# Notice of Allowability

10/604,734

MATTSSON ET AL.

## EXAMINER'S AMENDMENT

Fig. 1

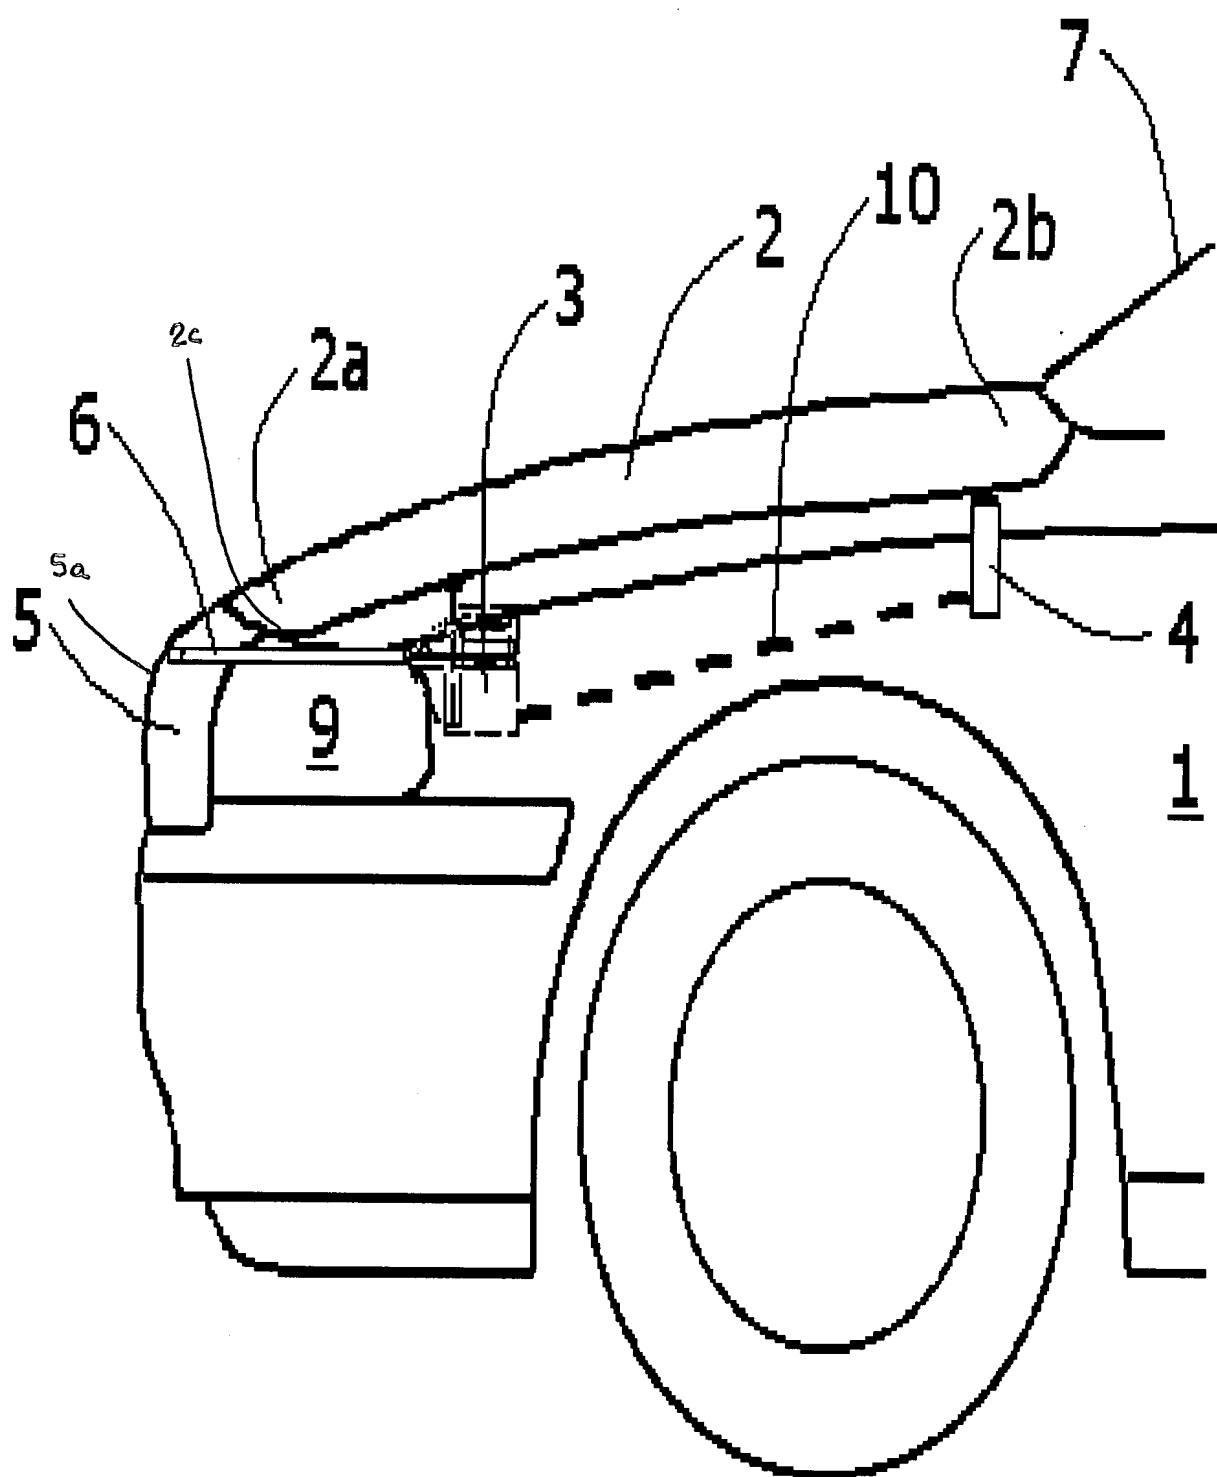
The latch mechanism **2c** and the grille opening reinforcement assembly **5a** have been added to **Figure 1**.

In order to avoid abandonment of the application, applicant must make these above agreed upon drawing changes.
